City of Albuquerque

RE: DRAINAGE REPORT FOR SHAW MOBILE HOME PARK
RECEIVED NOVEMBER 13, 1991 FOR PRELIMINARY PLAT APPROVAL
(M-21/D6)

**DRAINAGE MANAGEMENT PLAN
FOR
SHAW MOBILE HOME PARK
SUPPLEMENTAL DRAINAGE CALCULATIONS**

3. DROP INLET BOX & OUTLET

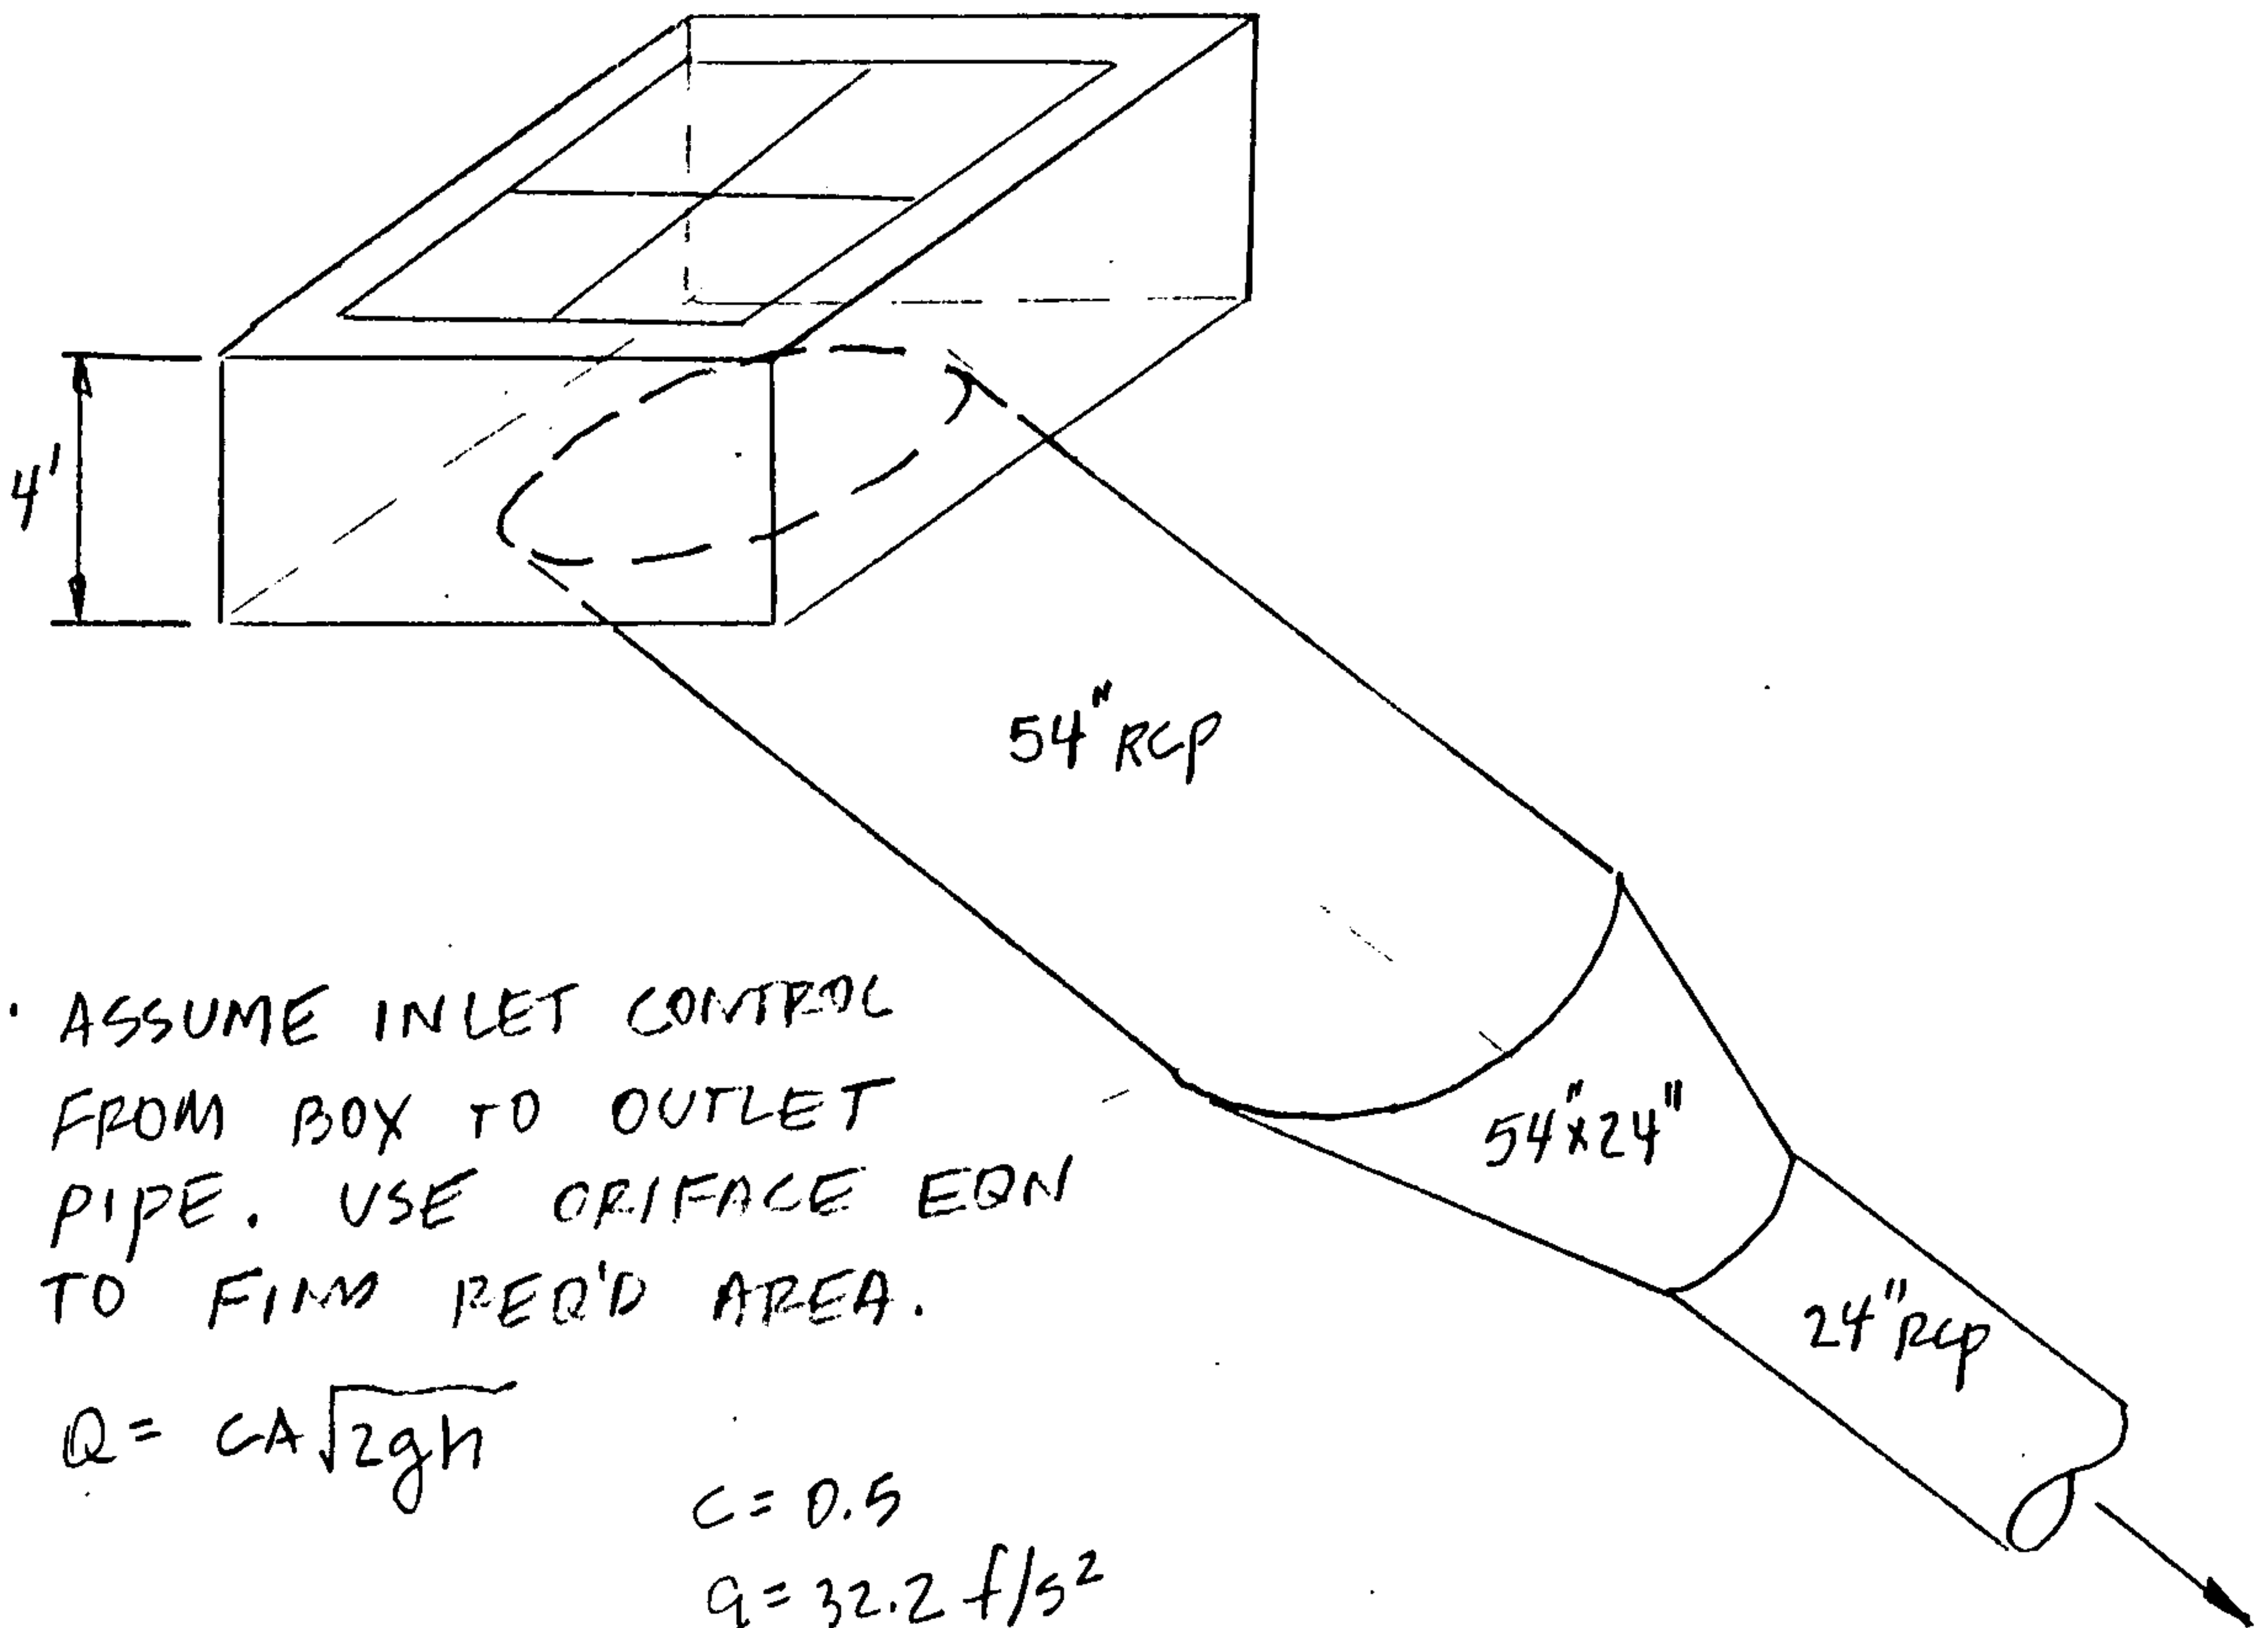
I cannot Agree with a 24" having this much

capacity due to slope, I believe the 24" with inlet control similar to sizing a culvert will be reqd.

B. SWALE ALONG GIBSON

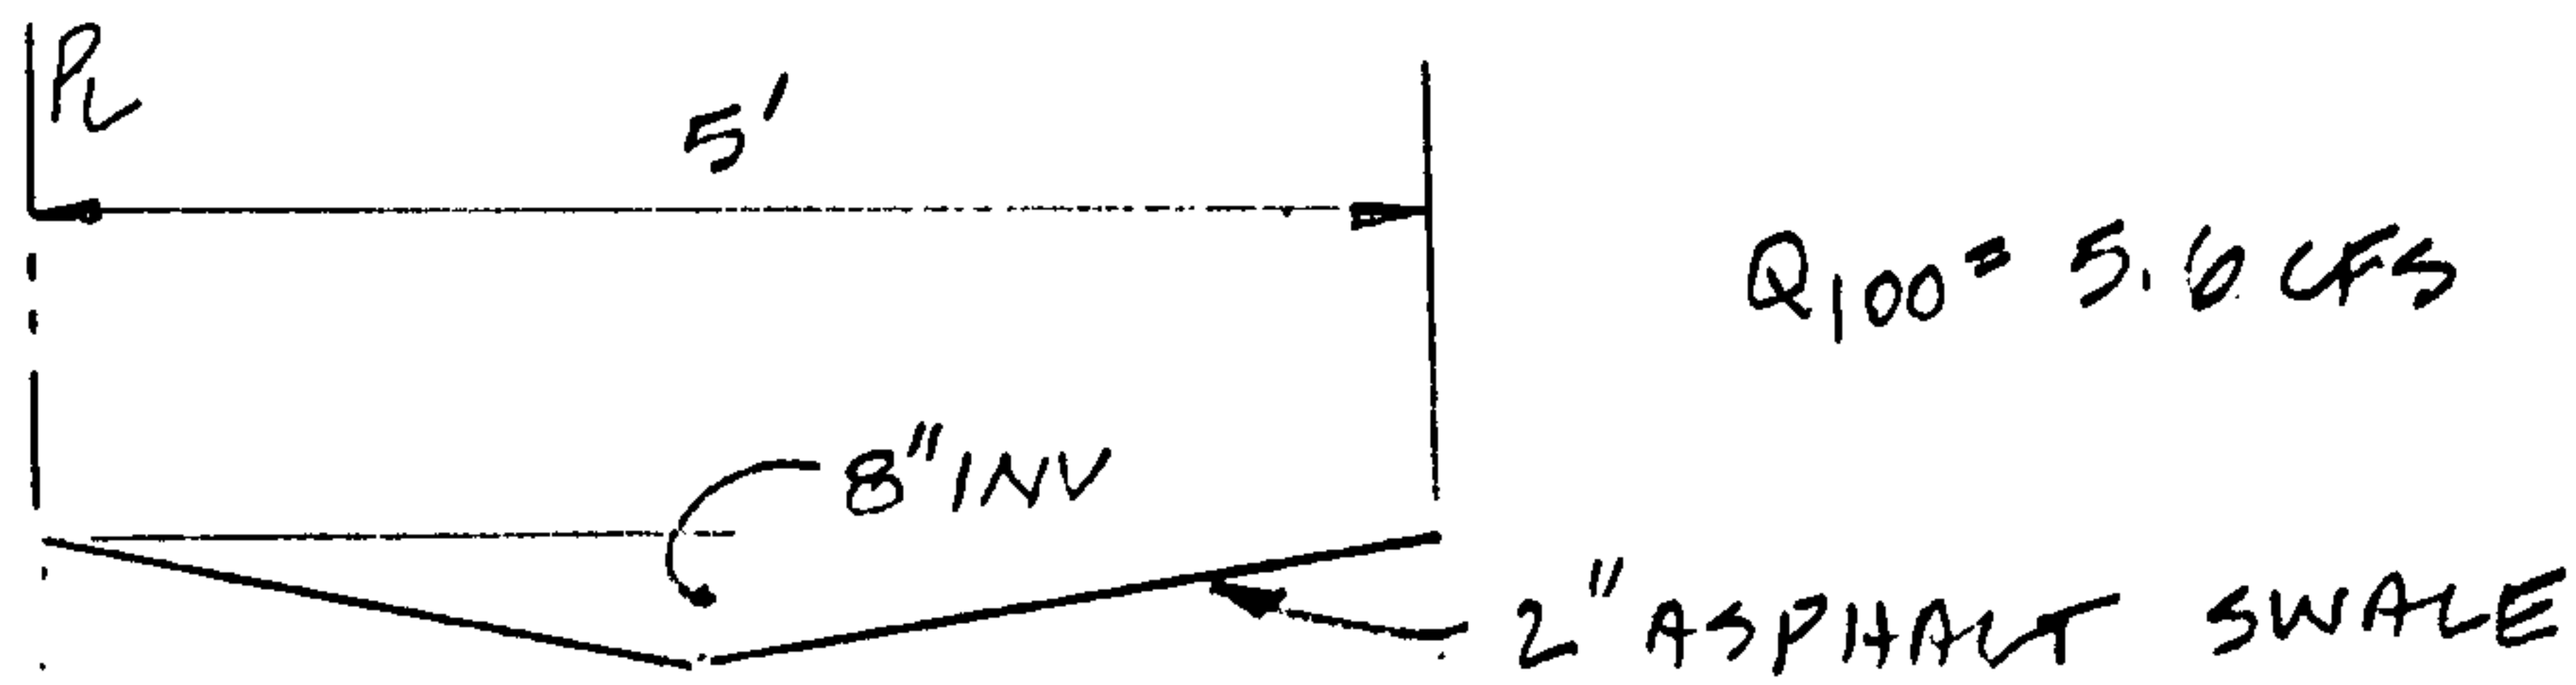
Who will maintain this section?

Street Classification
 is Arterial
 then Q100 Regd.
